2321 SCOTIA STREET (COMPLETE APPLICATION)  
DE410347 - ZONE C-3A

#### DEVELOPMENT PERMIT STAFF COMMITTEE RECOMMENDATION: APPROVE

Figure 1

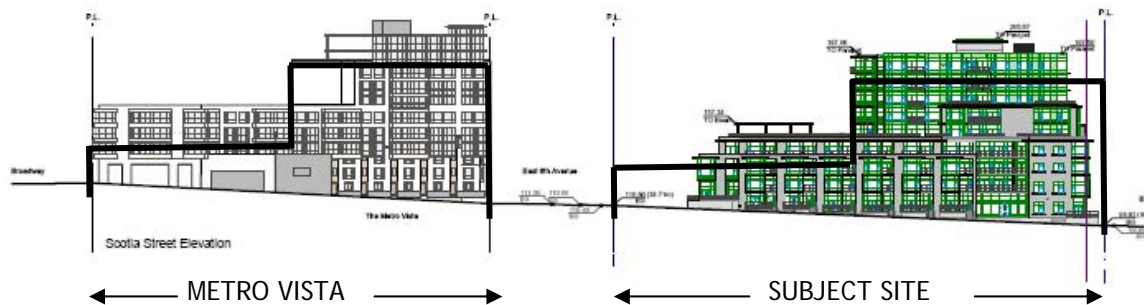
The proposed massing diverges from the suggested guideline massing as indicated in figure 1. The low-rise massing is slightly higher than the suggested 9.2 m (30 ft) across Scotia Street and East 7<sup>th</sup> Avenue frontages. Staff conclude this is supportable, noting that the suggested guideline height was intended to minimize shadowing on the north side of the east west axis of Broadway, while maintaining a continuous street wall along the commercial frontage. Shadow studies taken at mid day during the equinoxes indicate no shadow impact on the C-3A development to the west and the RM-4 development to the east, with minimal shadow intrusion on the IC-3 site to the north across East 7<sup>th</sup> Avenue. The slightly higher massing results in a smaller building footprint and increased setbacks for the higher massing, improving massing relationship with the lower scale context.

Figure 2

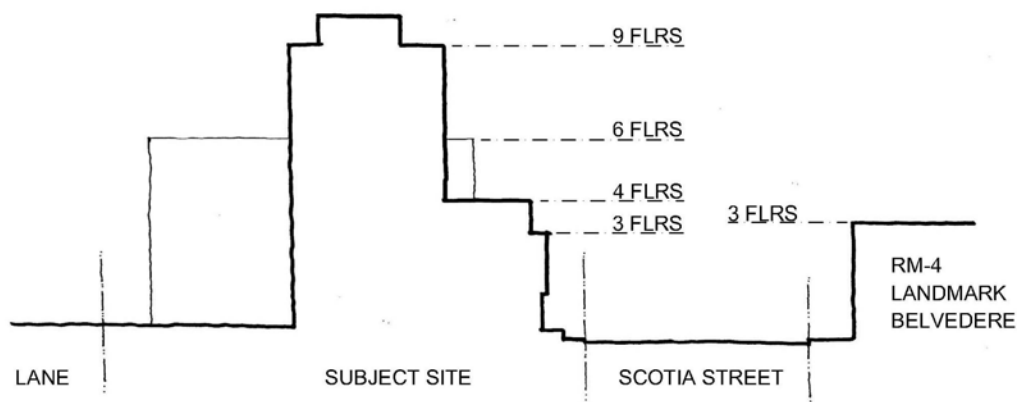
In response to these issues, the proposed massing along Scotia Street is four storeys in height with stepping of the building mass at the third floor. (See Figure 2.) Along the Scotia Street frontage, ground oriented townhouses are proposed in a 12 foot landscape setback. This compares favourably with the scale, massing and landscape treatment of the adjacent three storey Metro Vista townhouses to the south and the three storey Landmark Belvedere to the east. Along the East 7<sup>th</sup> Avenue frontage, ground oriented townhouses are also proposed within six storey massing, equal to the 60 ft. maximum allowable height for the IC-3 zone across East 7<sup>th</sup> Avenue, noting there is a heritage "C" building with one and two storey massing occupying a portion of the adjacent site across the street.

The proposed higher massing from the seventh to the ninth floor has been slimmed, reduced in floor area and building setbacks increased. Building setbacks for the higher massing along Scotia Street are 42 ft, with incremental stepping at the fourth, fifth and seventh levels. A building setback of 20 ft along East 7<sup>th</sup> Avenue is proposed for the higher massing, with stepping at the fifth and seventh levels. As suggested by the Urban Design Panel, staff consider the higher massing well placed on the site with a 120 foot separation from the Mt Pleasant Centre to the west. This distance exceeds livability standards of 80 ft separation typical for tall buildings in the downtown core. To the south, the Metro Vista building is 204 ft from the proposed higher massing.

Figure 3

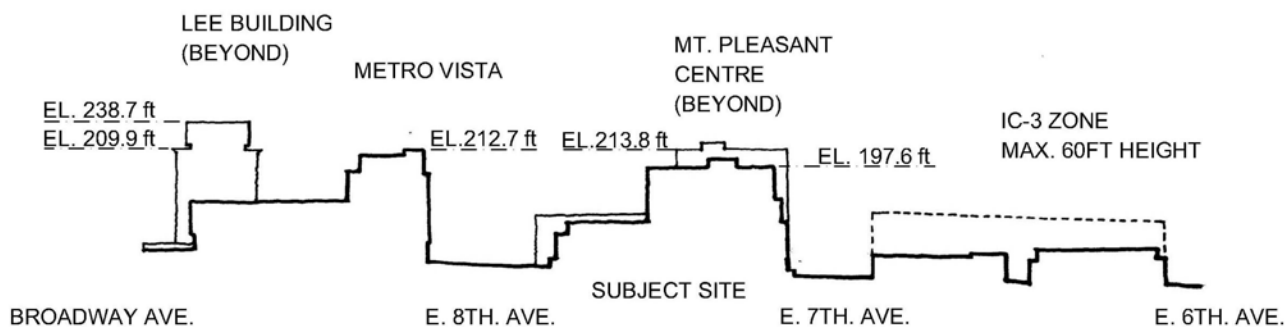
**Height and Private Views:** The intent of the guidelines is to maintain the Lee Building as a key reference for height in this area. Contextually the proposed elevation height is similar but slightly lower than the Lee Building, Metro Vista and the Mt Pleasant Centre, in part because of the descending grade. (See Figure 3) Staff is supportive of extra height beyond the suggested guideline height of 70 ft, because of the subject site's proximity to the topographical prominence of the central Mt Pleasant intersection of Broadway, Kingsway and Main Street, provided private views are not significantly impacted and there is an appropriate transition in scale to the low rise residential context in the adjacent RM-4 neighbourhood. The Urban Design Panel did not consider height to be an issue, acknowledging the revised scheme had satisfactorily resolved issues of scale and massing with the adjacent lower scale context.

View studies are provided in Appendix F. View studies from Metro Vista indicate the best potential view is northward between the subject site and Mt Pleasant Centre to the west. The 120 foot separation between these two buildings preserves a view amenity from the Metro Vista of the North Shore Mountains with a secondary view axis towards the northeast, south of the proposed building. Staff recognize that the ideal outcome for Metro Vista residents would be the retention of all panoramic views. However, the zoning suggests that view intrusion should be minimized where possible, and staff therefore suggest that heights similar to that approved for the Metro Vista and Mt Pleasant Centre can be considered for this application. In consideration of the residents of Metro Vista, the tenth floor penthouse dwelling unit proposed in the earlier scheme was removed, further reducing building mass at the building's roof line and improving views. Overlook for the Metro Vista neighbours to the south and future Mt Pleasant Centre neighbours to the west has been considered, providing a landscape amenity at the fifth floor terrace and a green roof at the seventh floor roof level.
